Access Compliance Report

Public Rights-of-Way

(Pedestrian Signals)

Intersection ID: N/A	Main Street:	Cross Street: N/A	Location: N/A
ADA ID: FE3F1F0A3F8E	Signal Type: One Push Button-Non APS	Overall Compliance: No	Severity Score: BTN 1: N/A BTN 2: N/A No BTN: N/A
Codes/Mitigation Info/Possible Solution		Field Measurements/Component Compliance

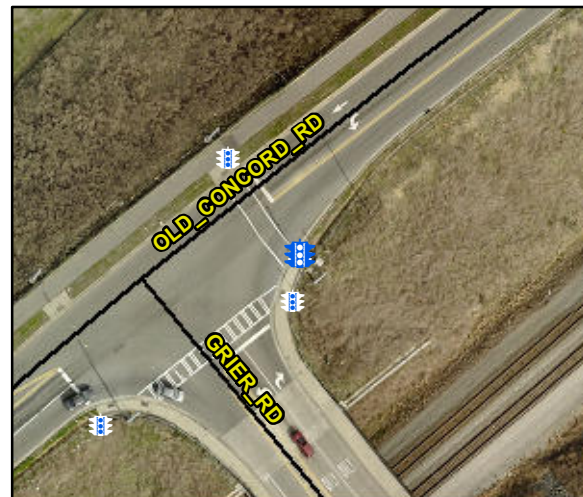
Surveyor Notes: TEXT HT 7/16, GUARD RAIL BETWEEN SIGNAL AND SIDEWALK

PROW/ADA: R410.6, R209.1, TMUTCD 4e.08, R404.2, R406.2

Possible Solutions: Replace Signal Push Button With APS Button on New Post. Remove & Replace Sign.
